MONTGOMERY COUNTY HISTORIC PRESERVATION COMMISSION
STAFF REPORT

Address:	5904 Cedar Parkway, Chevy Chase	Meeting Date:	2/12/2020
Resource:	Outstanding Resource Chevy Chase Village Historic District	Report Date:	2/5/2020
Applicant:	David O'Neil & Laura Billings (David Jones, Architect)	Public Notice:	1/29/2020
Review:	HAWP	Tax Credit:	n/a
Case Number:	35/13-20E	Staff:	Dan Bruechert
Proposal:	Window Replacement

Billings O'Neil Residence HAWP Revision 2

10. Dining Room Interior

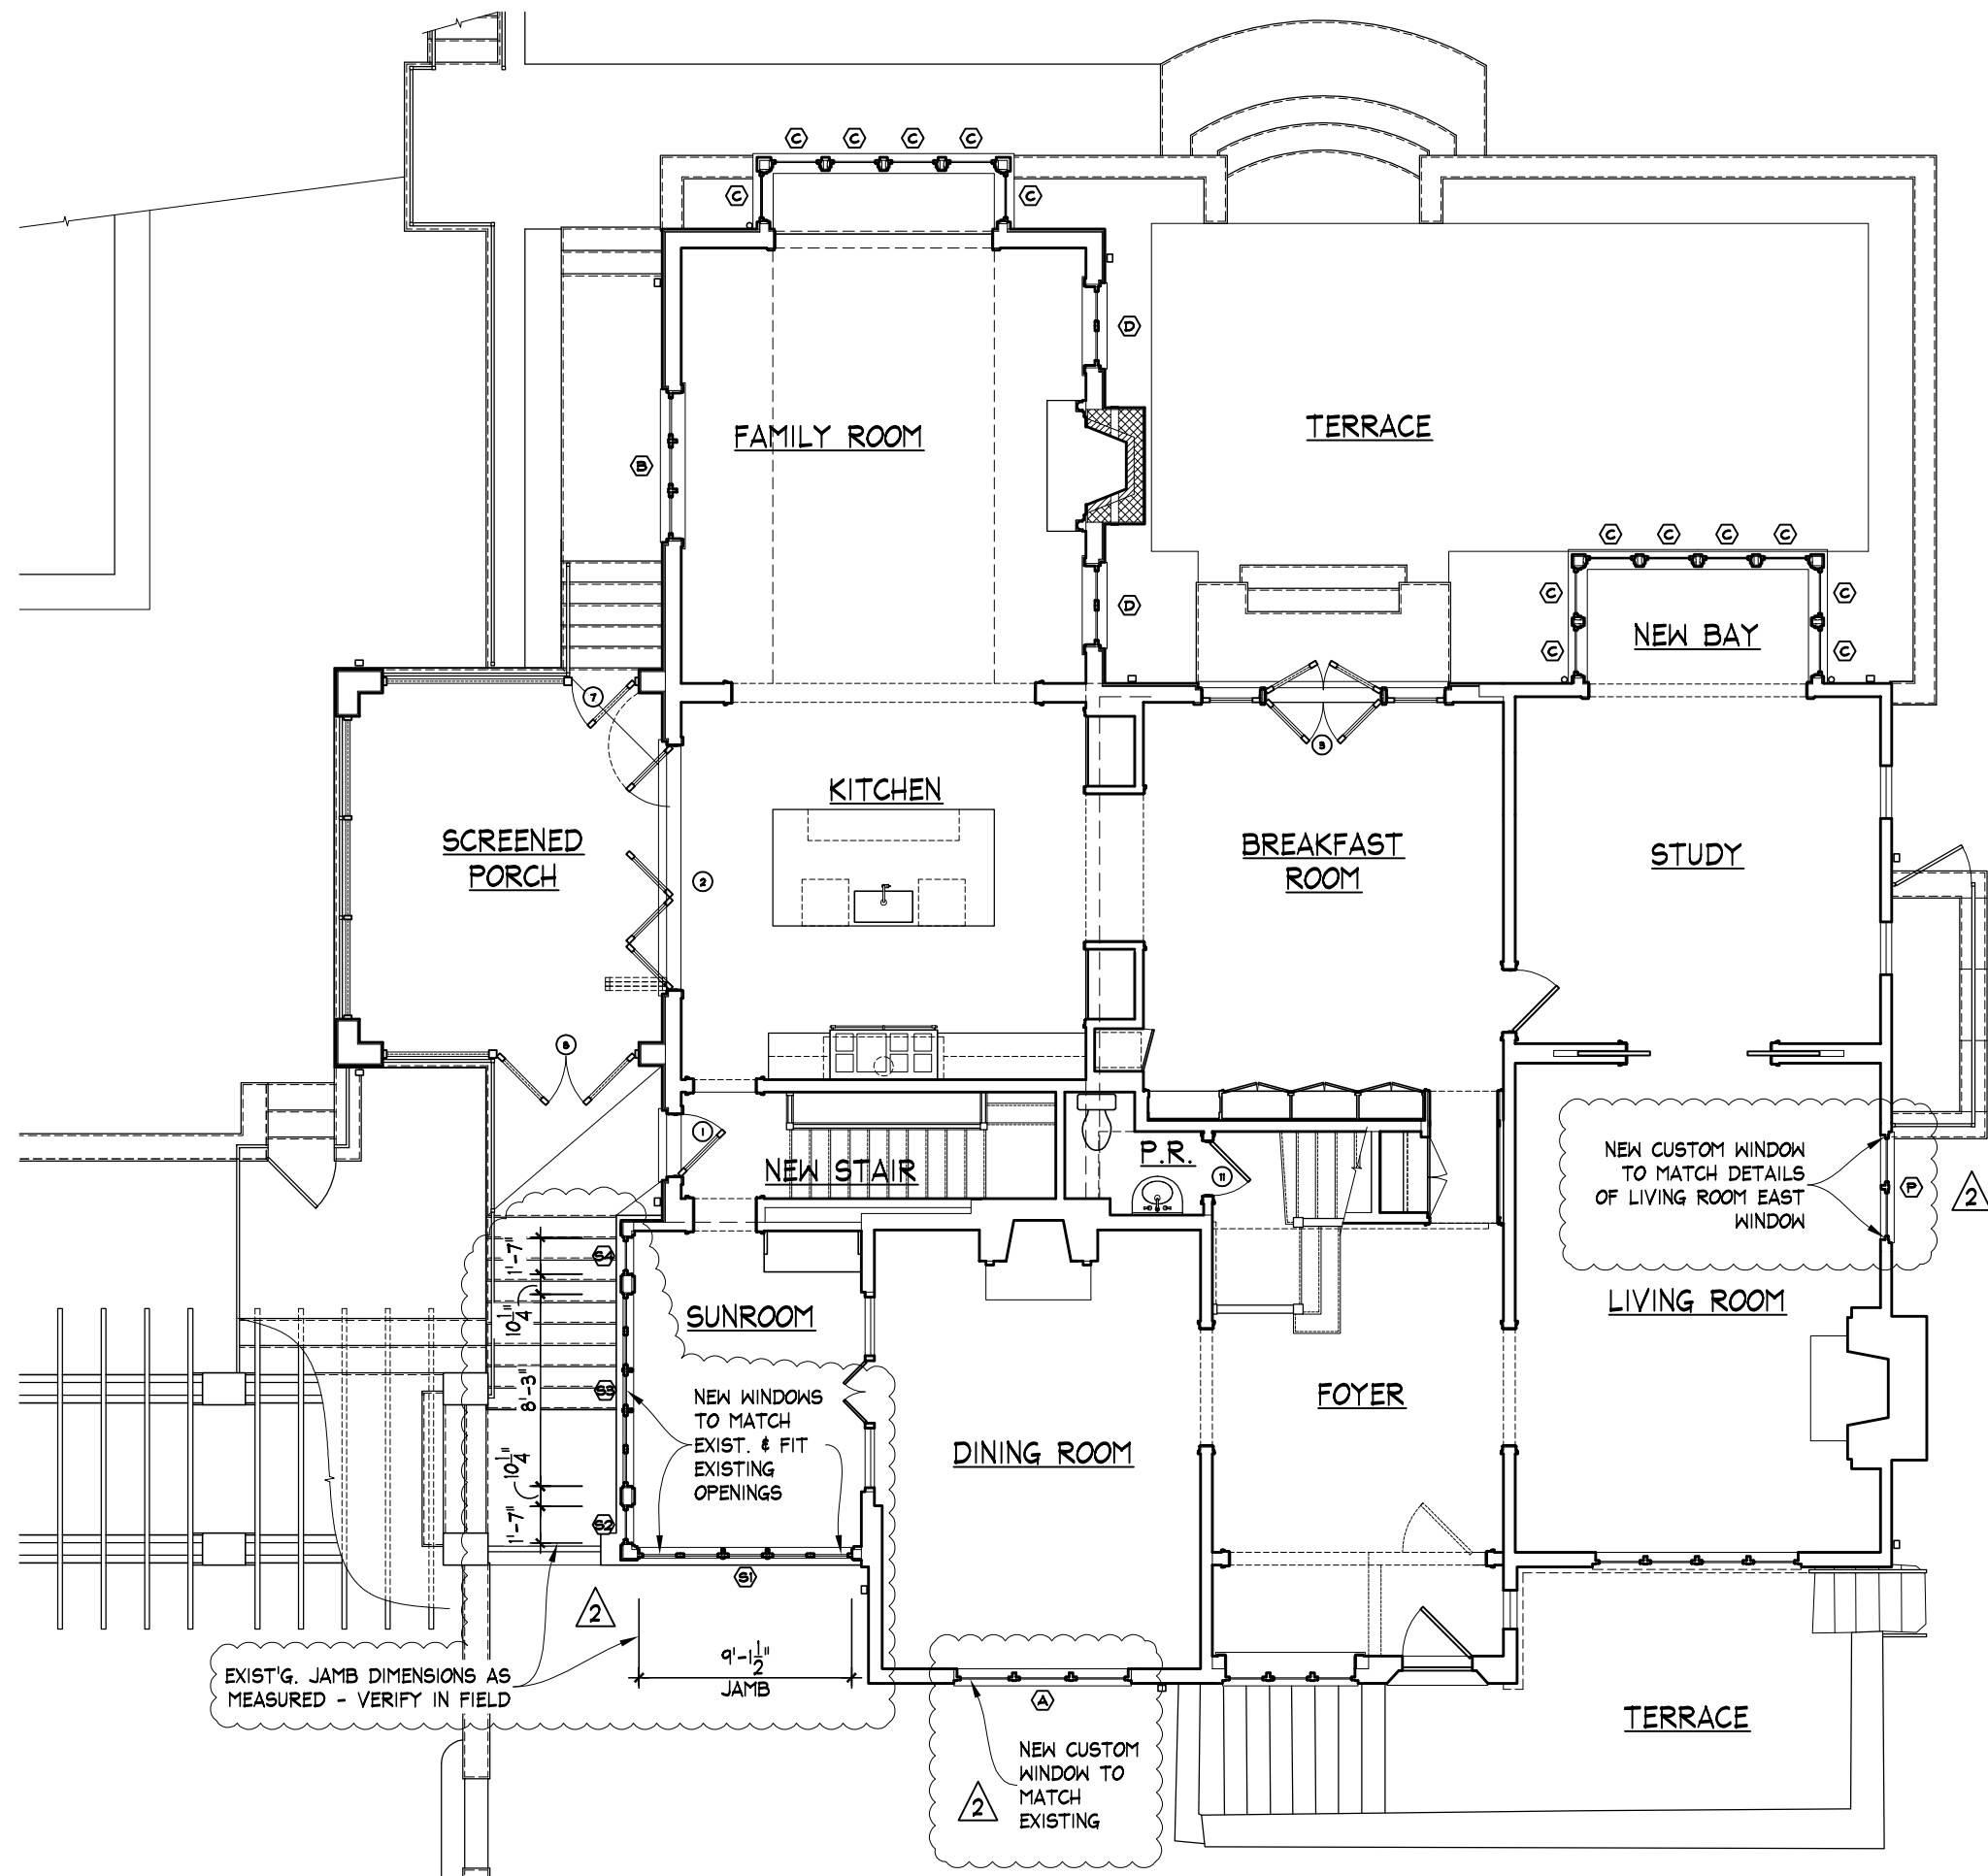
The original approved plans call for replacing the center sash. However, after further inspection, the two flanking sashes are rotted and will not close fully (photo 10). We propose to replace this window with a custom unit to match the existing details and frame dimensions.

11. Living Room Interior

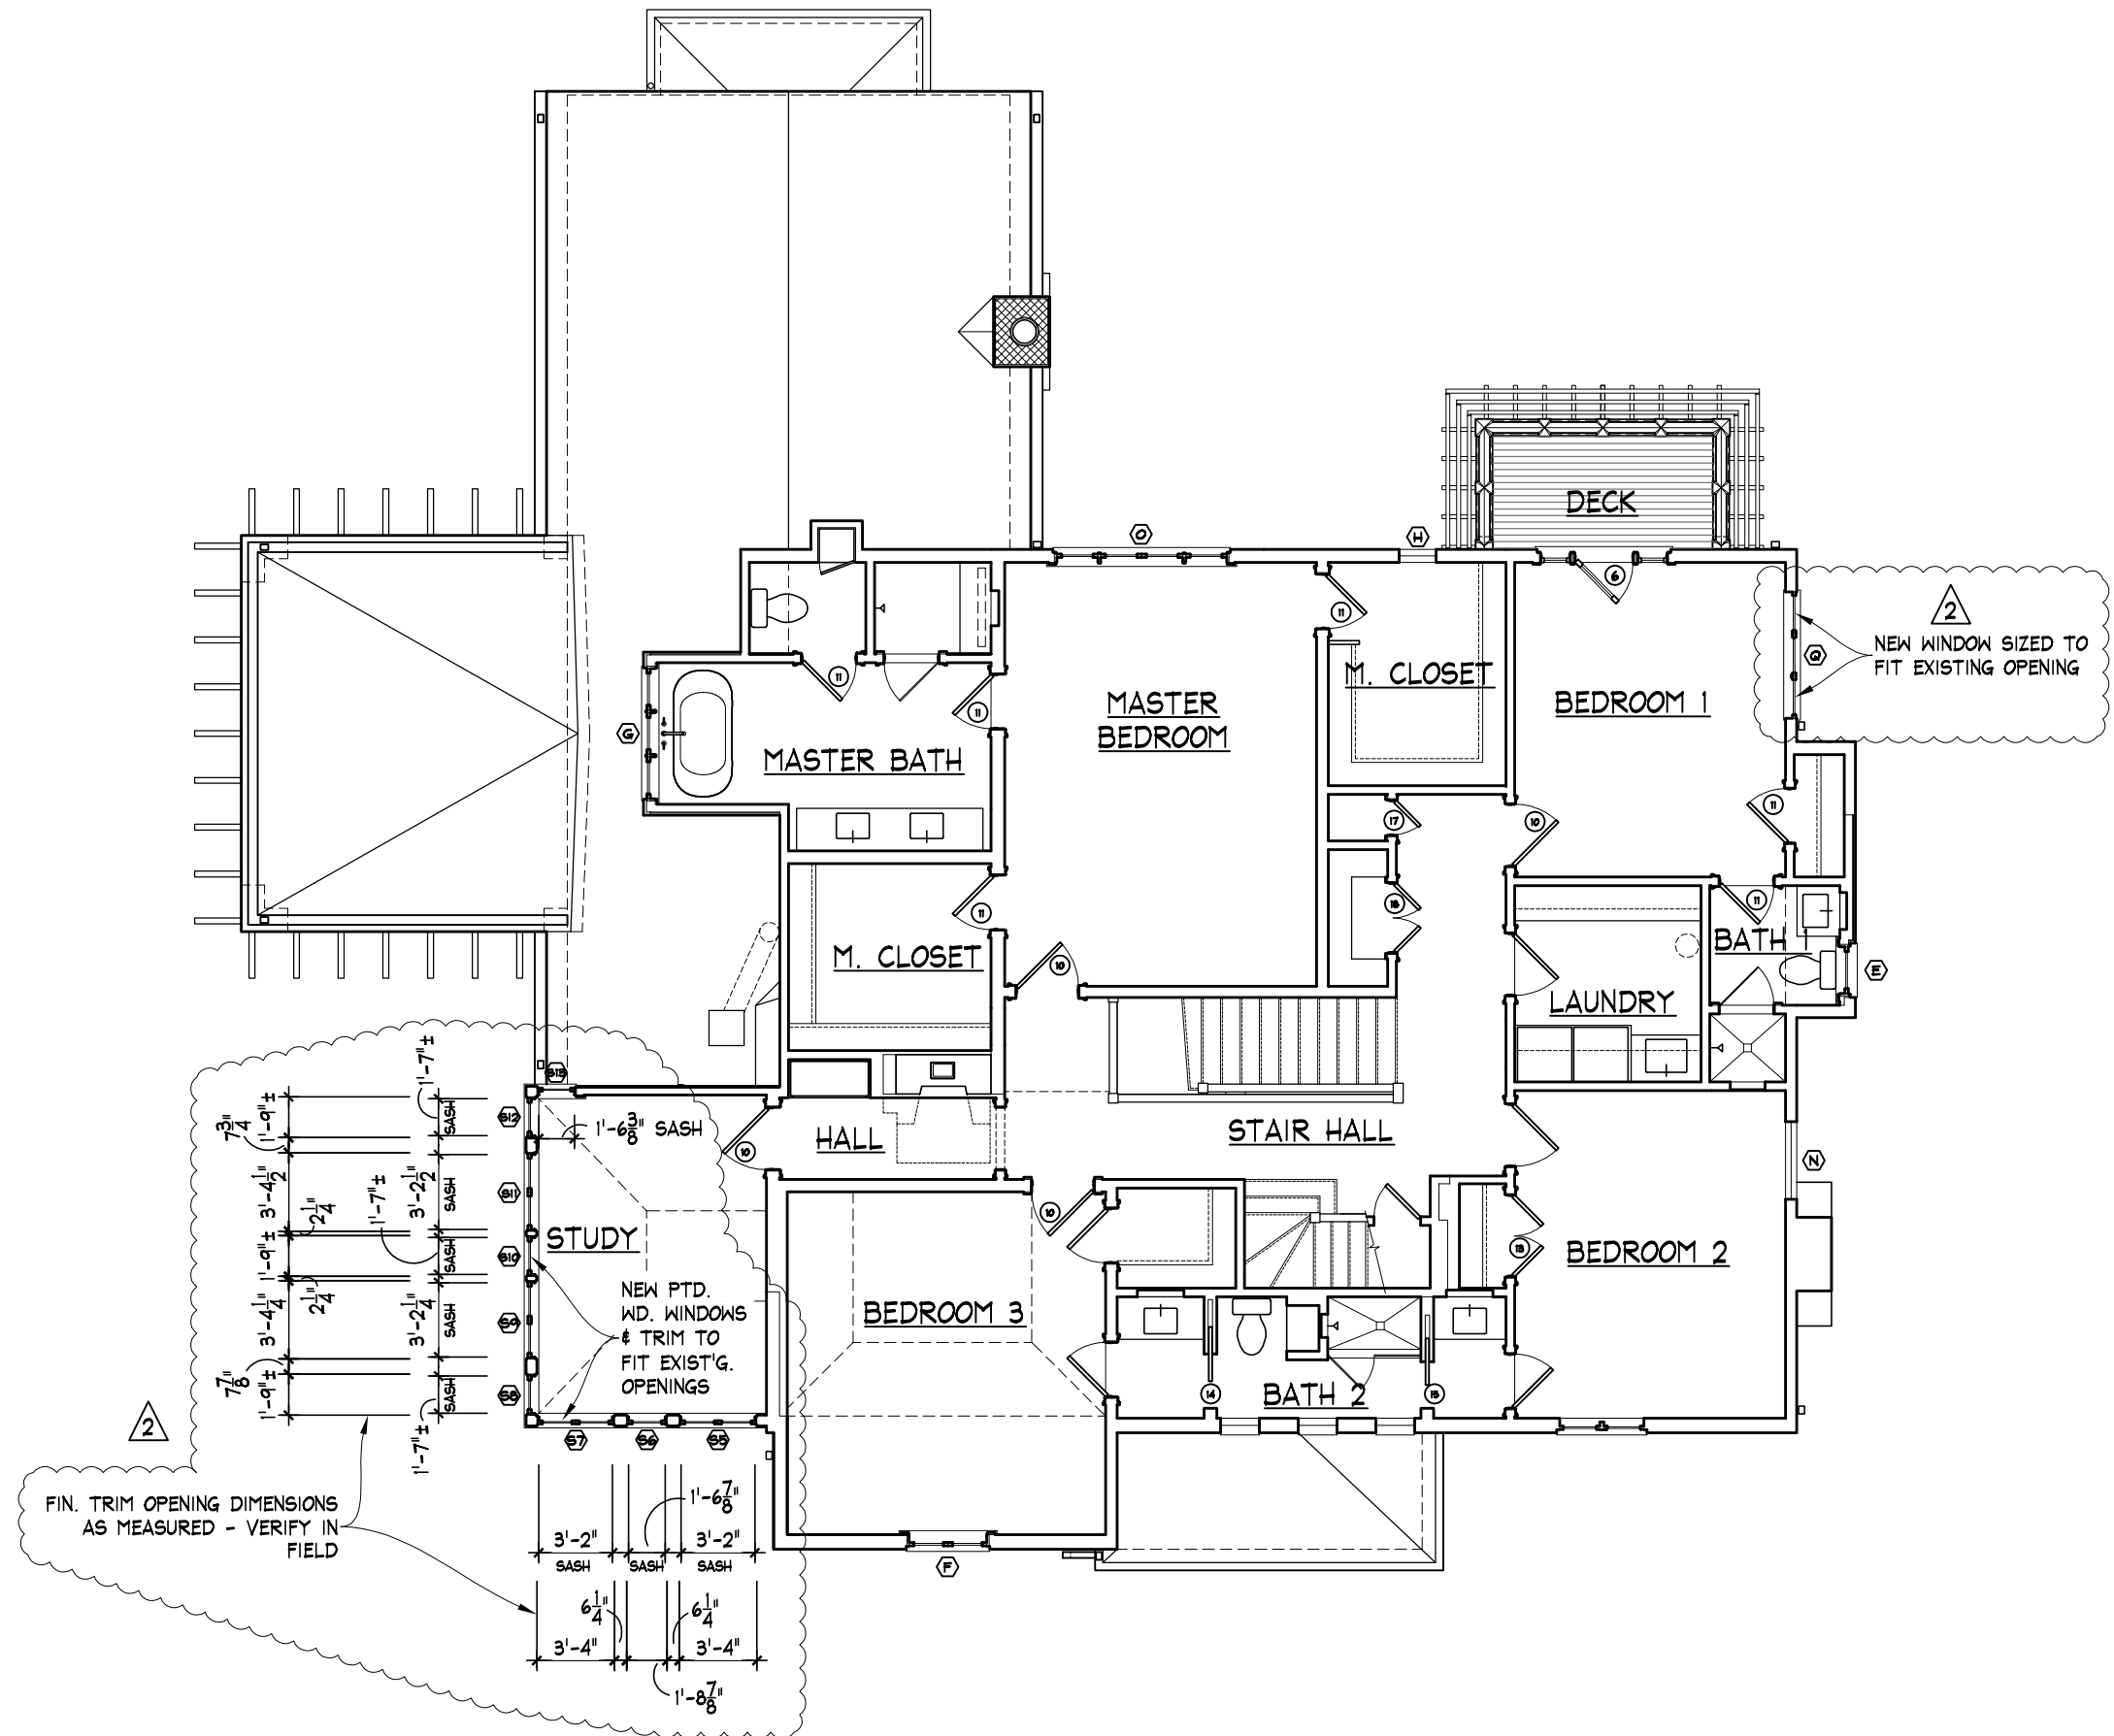
This window is rotted and will not operate (photo 11). We propose to replace with a custom unit to fit the opening and match the details of the Living Room window on the east elevation.

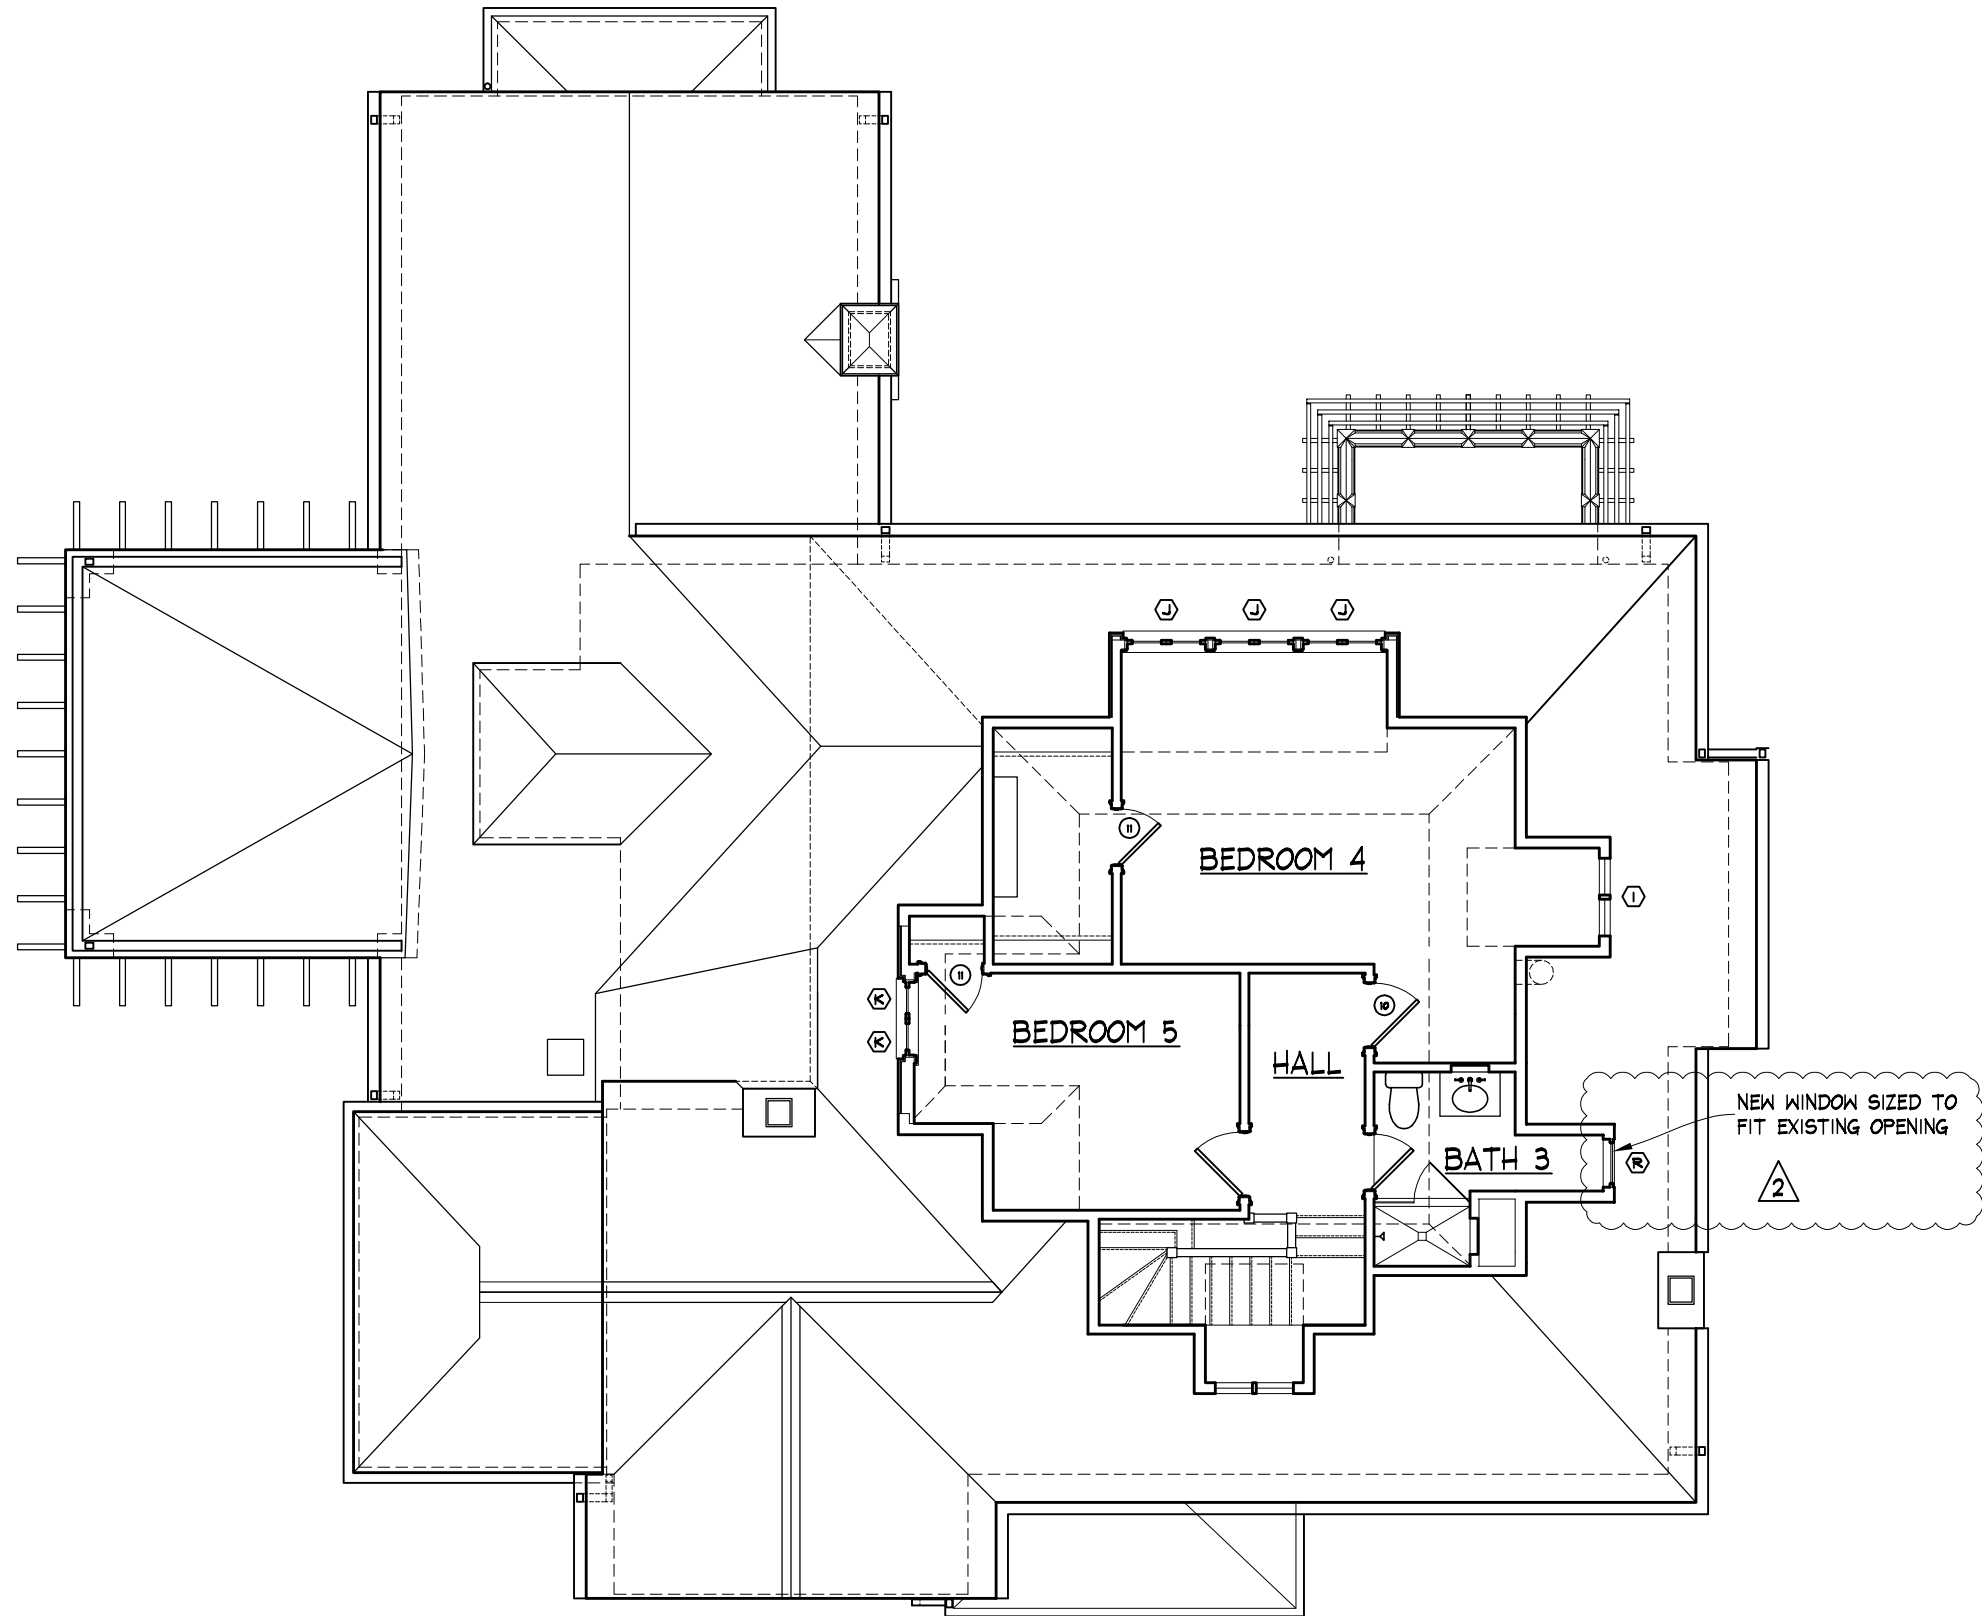
This window is rotted and will not operate (photo 12). We propose to replace with an operable window to match.
